**PLANNING COMMISSION
MEETING AGENDA
SPECIAL/STUDY MEETING**

July 26, 2011

9. PRELIMINARY SITE PLAN APPROVAL (SP 970) – Proposed Granite City Food & Brewery Restaurant, South side of Big Beaver Road, East of Troy Center Drive, Section 28, Currently Zoned BB (Big Beaver Form Based Code) District

Preliminary Site Plan Review For City of Troy, Michigan

PROJECT NUMBER
110215
 SHEET NUMBER
A210

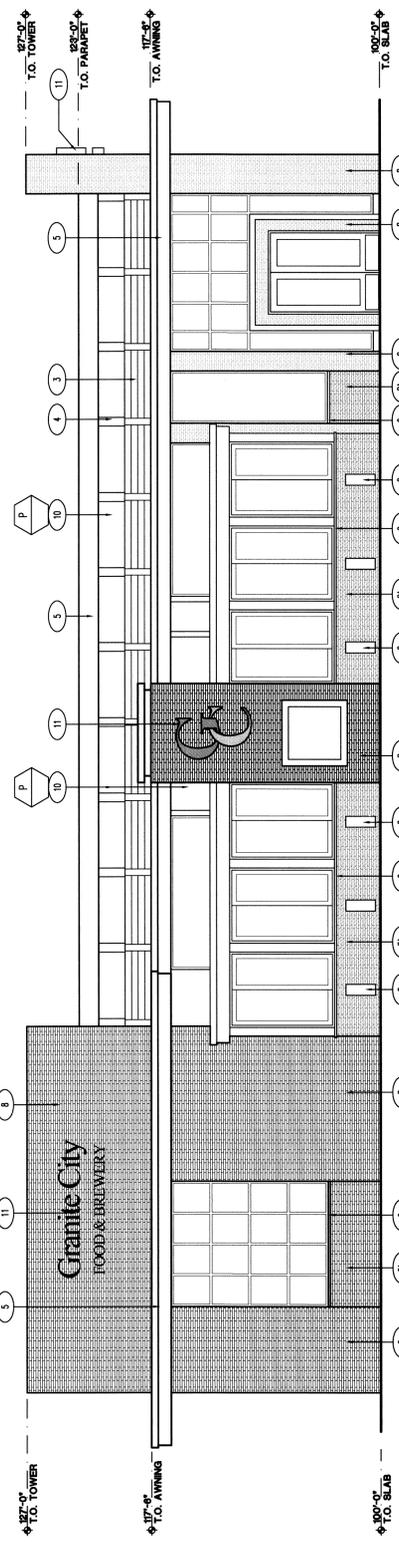
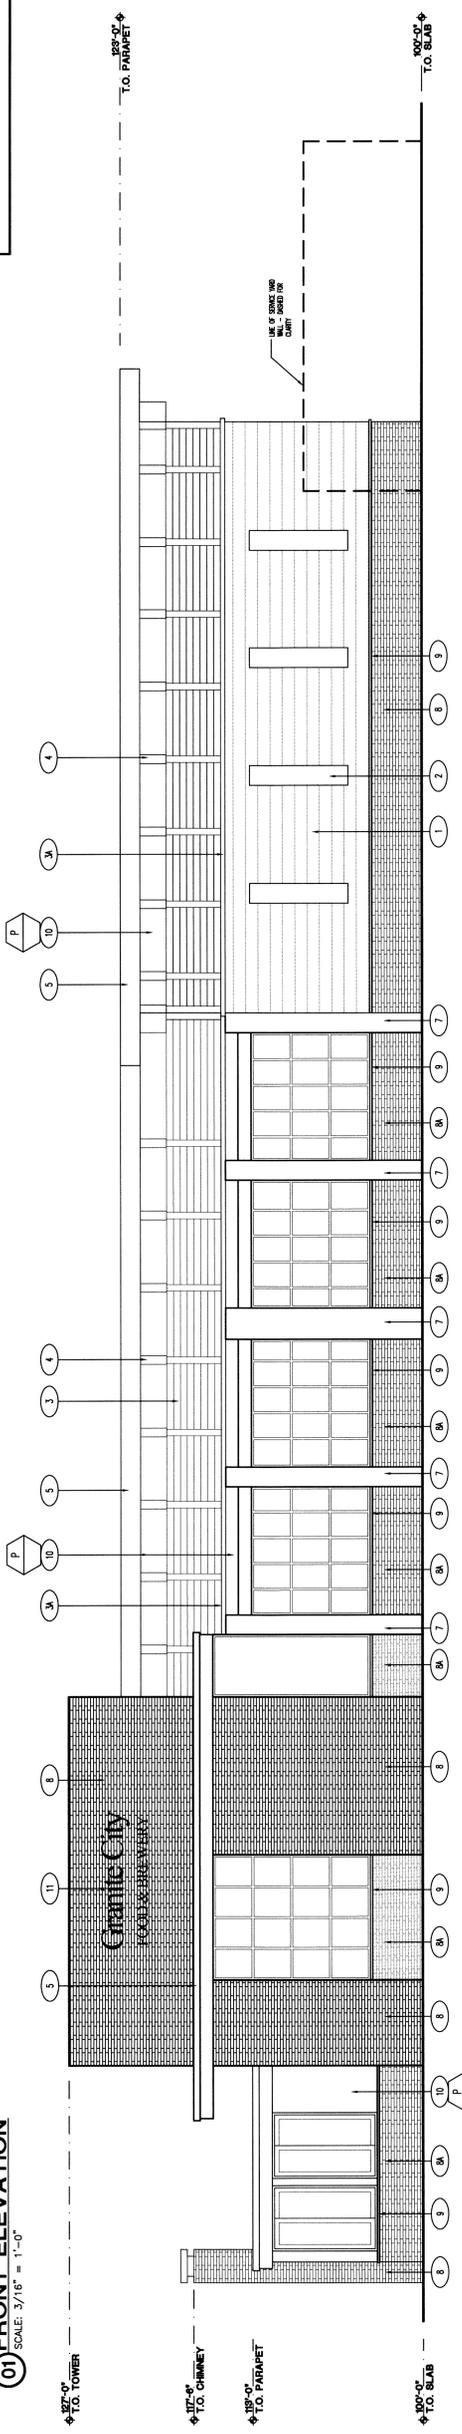
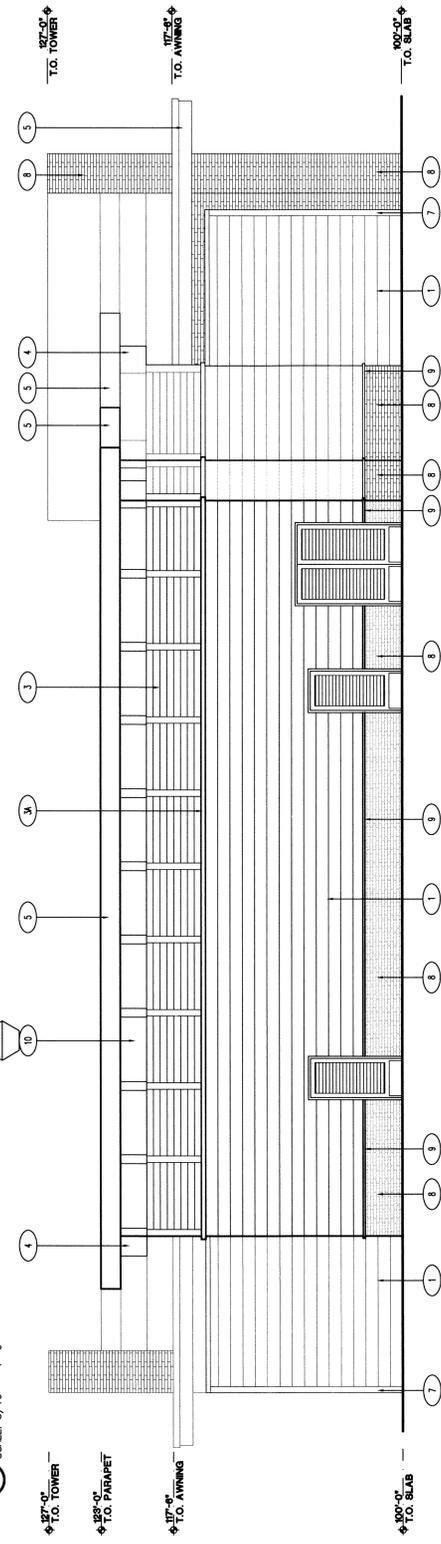
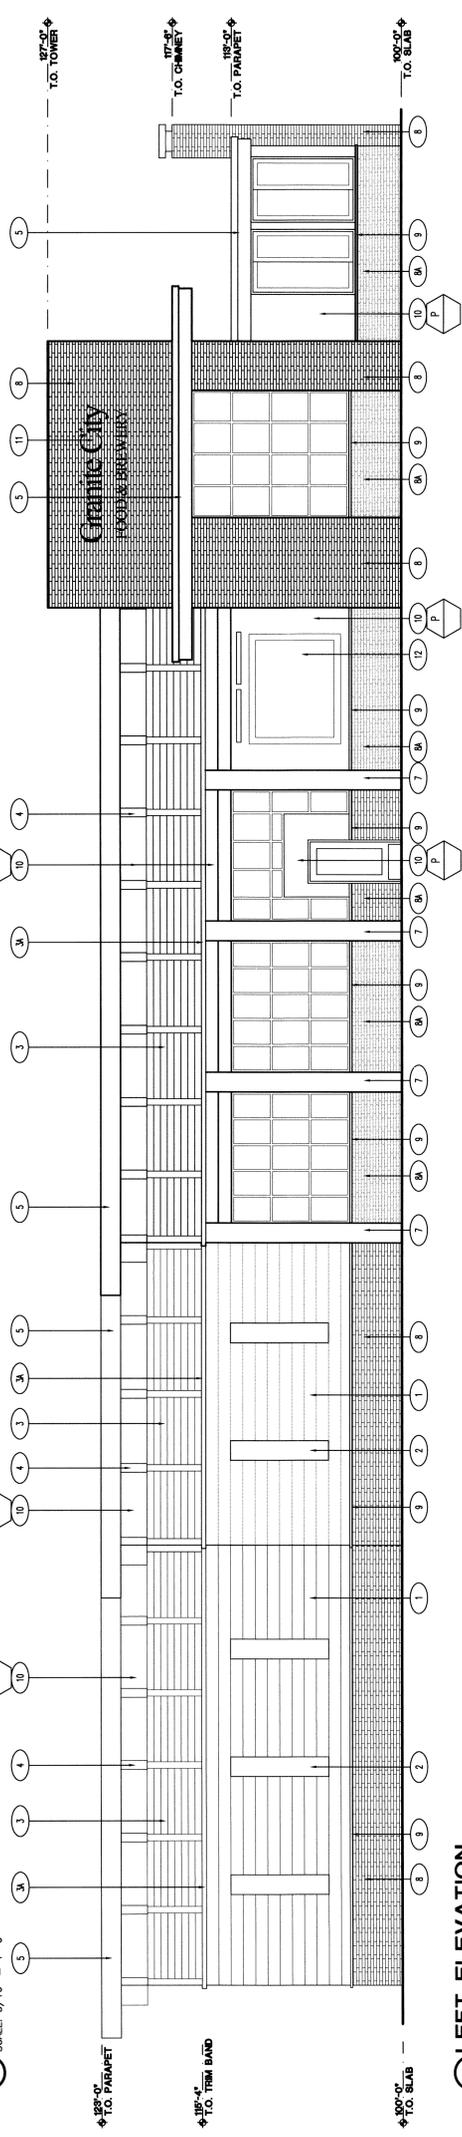
***The minimum ground story height must be 14 feet or greater. While it appears that the proposed elevations demonstrate that the building is well in excess of this requirement, they only provide dimensions to the parapet and tower, not to the roof deck itself. A revised set of elevations should demonstrate that the roof deck is 14 feet or higher from the first floor grade.

1. Correct the east boundary labels and setback lines to reflect its condition as a side yard.
2. Demonstrate that the first floor is 14 feet or taller in height.
